RE: Responses to the Environmental Report Request for Additional Information for the Nichols Ranch  
ISR Project License Application (TAC J00553, Docket No 040-09067)

**Request for Additional Information  
Regarding the Uranerz Energy Corporation's  
Nichols Ranch ISR Project License Application  
Environmental Report – Uranerz Energy Corporation Responses**

FIGURE 3-23

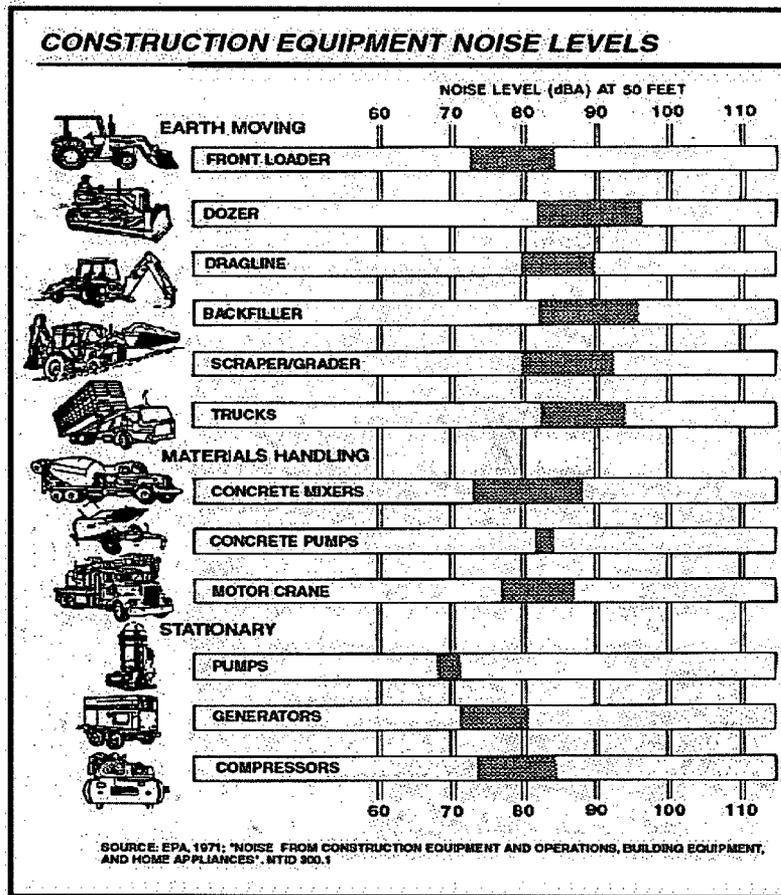
- a) Provide projections of typical equipment and their reference sound levels that would be associated with activities during each phase of the proposed project.

Typical equipment that will be used for the Nichols Ranch ISR Project and their noise levels are below. Section 4.9.1 has been revised to include this information.
